**Item 3.****Development Application: 21 Kellett Street, Potts Point - D/2019/621**

File No.: D/2019/621

**Proposal Summary:** Approval is sought for the demolition of an existing single storey triple garage and construction of a part four part five storey mixed use development. The proposal includes a six room boarding house, basement services, ground floor retail space and communal indoor/outdoor space on the top floor.

**Figure 15:** Original six storey proposal (southern Mansion Lane elevation)

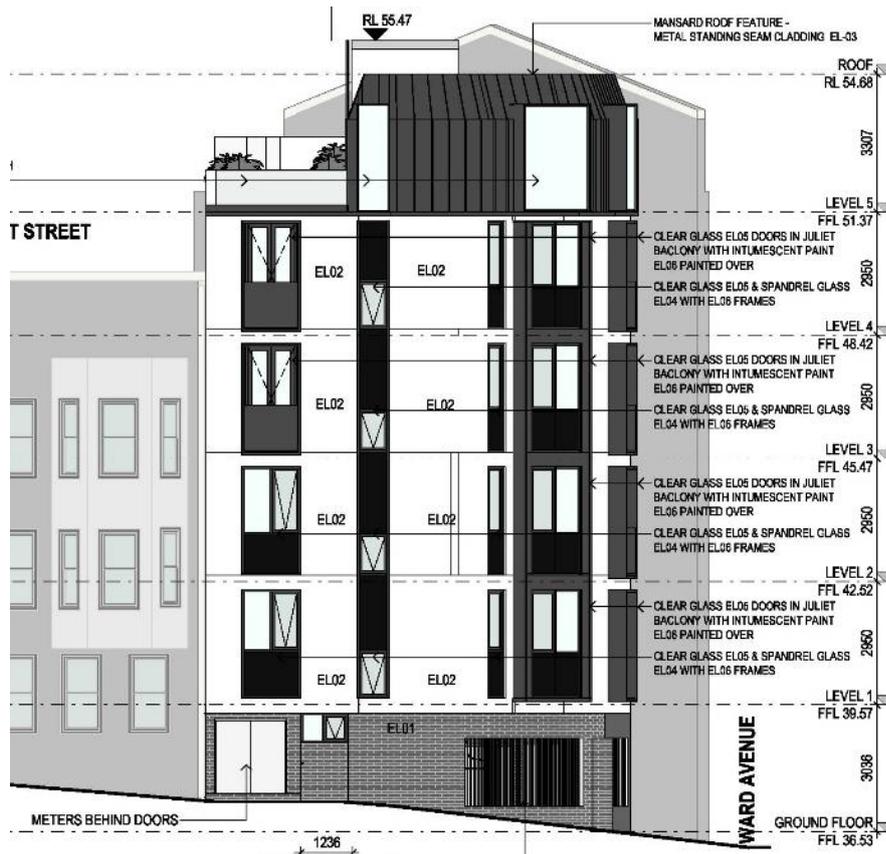
74. The proposal was originally designed as a six storey building, as shown in Figure 15. The original proposal was not supported due to the following:

- (b) the development was contrary to the Kings Cross Locality Statement that requires development to respond to and complement heritage items and contributory buildings within heritage conservation areas, including streetscapes and lanes;

- (c) the proposal was not designed to respect the neighbouring contributory building at 19 Kellett Street as it did not provide a sympathetic transition of height between buildings. It proposed an awkward junction between the proposed building and the contributory neighbouring building. The proposed building also did not relate to the building directly across Mansion Lane (rear of 36 Bayswater Road).

75. The applicant was required to amend the proposal to address the above issues. Amended plans were received showing a reduction in one storey, as shown in Figure 16.
76. While still non-compliant with the height in storeys control, the revised proposal is acceptable from a heritage and streetscape point of view as follows:
  - (a) it provides an appropriate response to the adjoining building at 19 Kellett Street, with the parapets of both buildings aligning at the top floor;
  - (b) provides an appropriate height transition between the existing building at 19 Kellett Street and Eastend Lodge to the north;
  - (c) the proposed will not result in unacceptable overshadowing or privacy impacts as a result of the additional height.

**Figure 20:** Adjoining windows to 19 Kellett Street identified in red

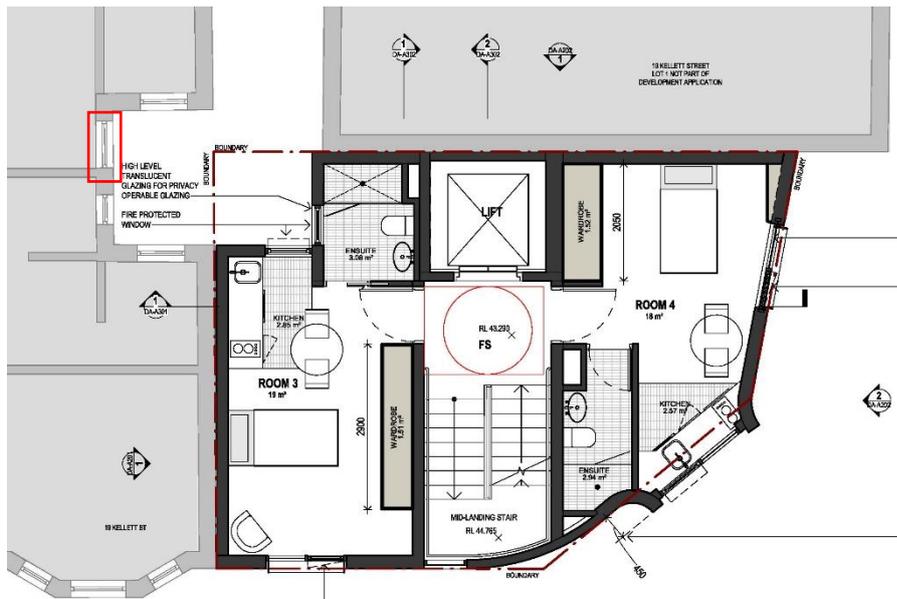
91. Section 4.2.3 of Sydney DCP 2012 outlines the provision for solar access to adjoining properties. The DCP specifies that neighbouring developments must receive a minimum of 2 hours direct sunlight to at least 1sqm of living room windows on the 21 June.
92. The adjoining property at 19 Kellett Street contains units with windows that face onto the internal light well. The majority of these windows are to bathrooms and kitchens and are not protected under the DCP control. A number of these windows however, are to living rooms, as shown with the red line in Figures 19 and 20.

93. Shadow diagrams submitted with the application show that the light well is entirely in shadow on the 21 June. This is as a result of the existing six storey building to the north of the subject site, as well as overshadowing caused by the 19 Kellett Street building itself. The location of the proposed building to the east and south of the living room windows at 19 Kellett Street, and the setback to the internal light well results in no additional overshadowing to this adjoining property.
94. The proposal will not result in any additional overshadowing of living room windows to units at 19 Kellett Street between the hours of 9am and 3pm on the 21 June and is acceptable with regard to overshadowing.

Figure 21: Original level 1 floor plan built to the boundary of the internal light well

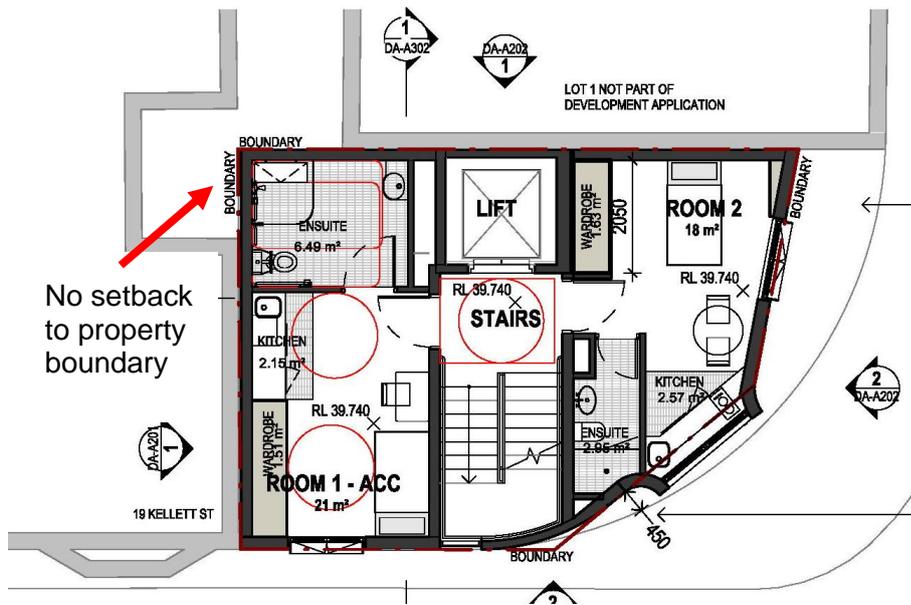
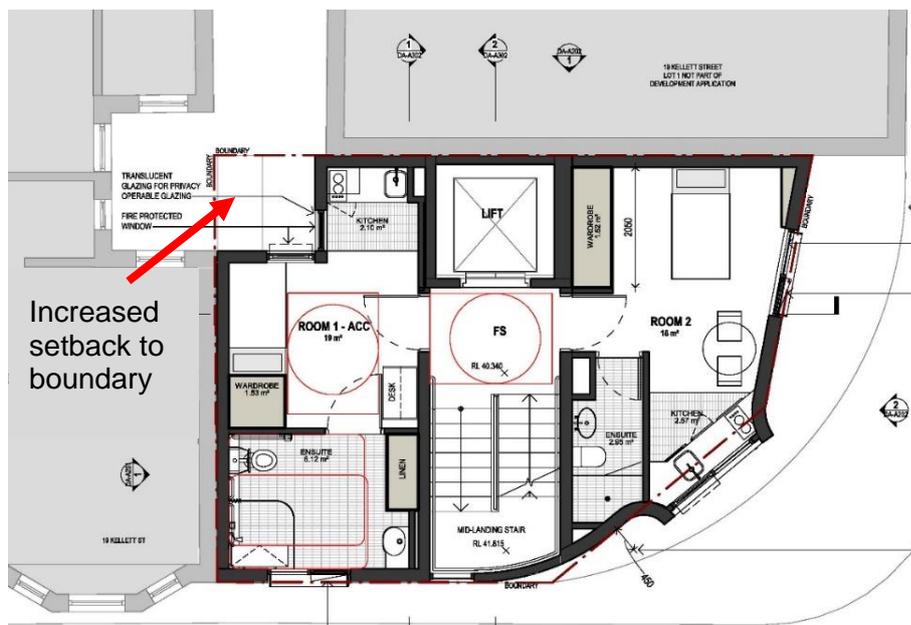
97. The proposal was originally designed with a reduced setback to the shared light well to 19 Kellett Street at the ground floor and level 1. This allowed a compliant room size to the accessible room, as shown in Figure 21.

98. Following an assessment of the proposal, including review by the City's Design Advisory Panel, concerns were raised regarding the potential impact of the proposal on the amenity of ground and level 1 units at 19 Kellett Street. The applicant was requested to amend the layout of the ground and first floor to increase the setback of these levels to align with the floors above (see Figure 22).

99. The amendments resulted in the reduction in size of the level 1 accessible room. While compliance with the numerical room size requirement is not achieved, the accessible room is able to provide a functional layout that still achieves a basic level of internal amenity, while protecting the amenity of the adjoining property.

**Response** - The proposal has been amended to show a setback of 1.7m to the property boundary and light well, which is consistent with the setback of the building to the north. It is noted that the building at 19 Kellett Street is built to the boundary and does not provide a setback aside from the light well, and that other units within this building have a similar existing arrangement to what is proposed. The building setback is acceptable with regard to the site constraints and the controls of the site.
